**SUSQUEHANNA STEAM ELECTRIC STATION
PROPOSED AMENDMENT NO. 318 TO UNIT 1
FACILITY OPERATING LICENSE NPF-14 AND
PROPOSED AMENDMENT NO. 290 TO UNIT 2
FACILITY OPERATING LICENSE NPF-22: REVISE
TECHNICAL SPECIFICATION 3.4.10 "RCS PRESSURE
AND TEMPERATURE (P/T) LIMITS"
PLA-7181**

**Docket Nos. 50-387
and 50-388**

UNIT 1 AND UNIT 2 CHANGES TO TECHNICAL SPECIFICATION 3.4.10

**PROPOSED TECHNICAL SPECIFICATION
CHANGE
(MARKUPS)**

Minimum Reactor Vessel Metal Temperature (degrees F)
FIGURE 3.4.10-1
System Hydrotest Limit with Fuel in Vessel for 35.7 EFPY
(Curve A)

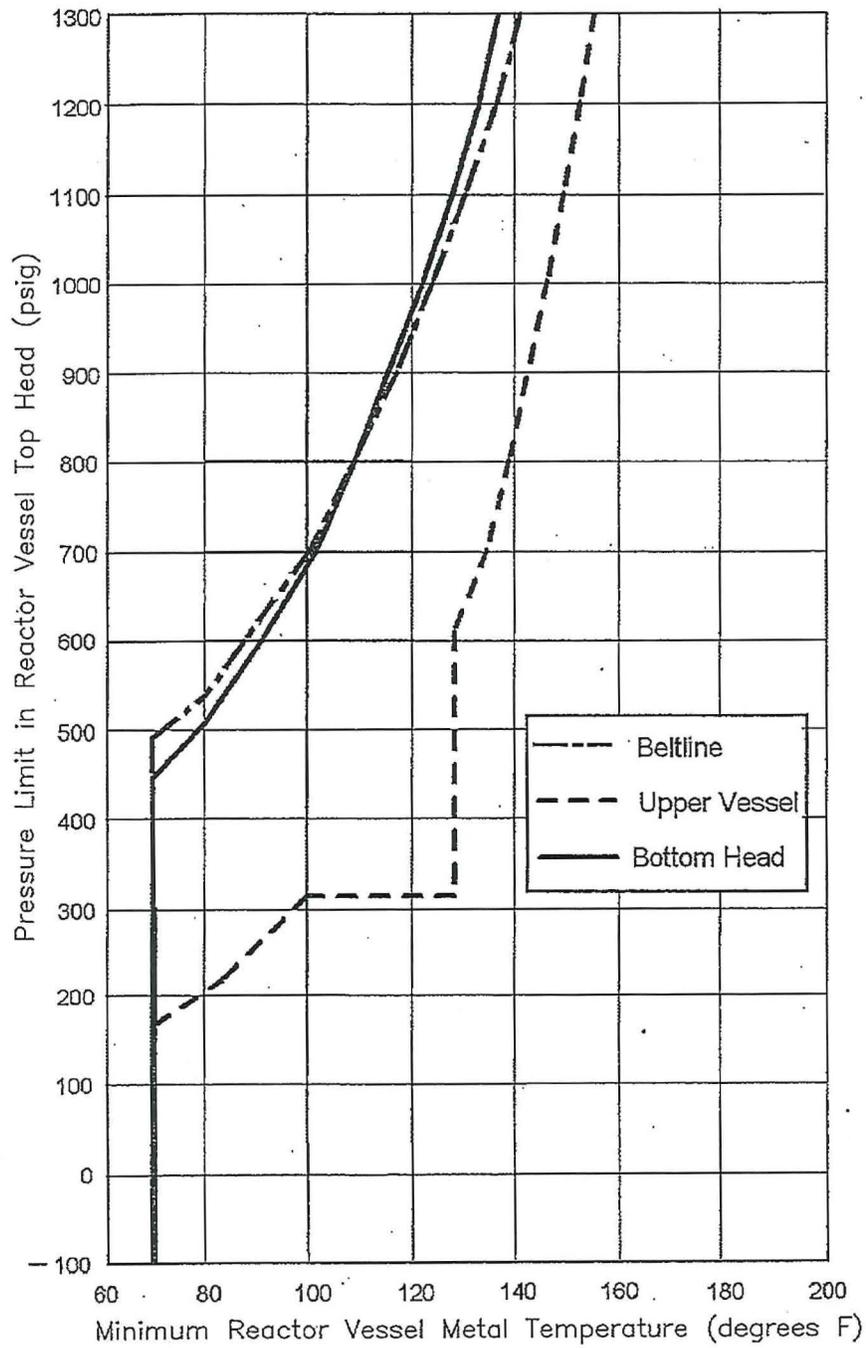
The proposed changes are to TS Figures 3.4.10-1, 3.4.10-2, and 3.4.10-3, which show the P/T Limits curves for in-service leakage and hydrostatic testing, non-nuclear heatup and cooldown, and criticality, respectively.

The proposed P/T Limits curves are valid for 35.7 EFPY for SSES Unit 1 and 30.2 EFPY for SSES Unit 2. The plotted values of the proposed curves at and above the 0 psig value for the reactor vessel top head pressure are identical to the plotted values on the present curves contained in NRC-approved amendments 232 and 209 for Unit 1 and Unit 2, respectively (Reference 7.1). The proposed change for each P/T Limits curve is to extend the curve below 0 psig to define the minimum reactor vessel metal temperature at a reactor vessel tophead pressure below 0 psig is 70 degrees F.

No. The proposed changes request that the P/T limits curves in TS 3.4.10, "RCS Pressure and Temperature (P/T) Limits" be revised by extending each of the P/T Limits curves below 0 psig to allow operation with the RPV at a vacuum.
